Remarks

This amendment responds to the official action of April 14, 2009 and is accompanied by a petition for one month extension and the necessary official fee.

Docket No.: D4700-00419
P 43023 WO/US

FIG. 1

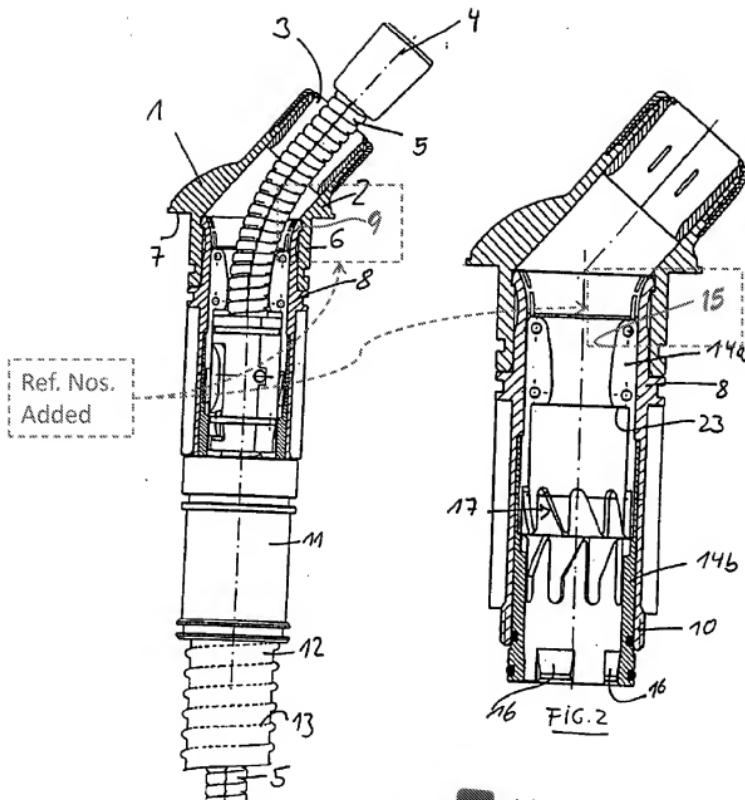
An objection was made to the drawings for inclusion of extraneous lead lines and for missing reference numbers 9 and 15, found in the written description. As mentioned at page 8, line 22, circumferential rim 9 in Fig. 1 locks extension part 8 into socket 6. As mentioned at page 9, line 2, a curved inner wall 15 is at the upper region of top part 14a in Fig. 2. Applicant submits substitute drawings that include these two reference numbers. No new matter is presented because the reference numbers routinely illustrate subject matter found in the description as filed. In Figs. 3, 6, 7 and 9, extraneous lead lines as well as extraneous partially obscured labels are removed. Annotated copies appended to these Remarks as exhibits show the changes made. Applicant requests reconsideration and withdrawal of the objection to the drawings.

Remove
Extraneous
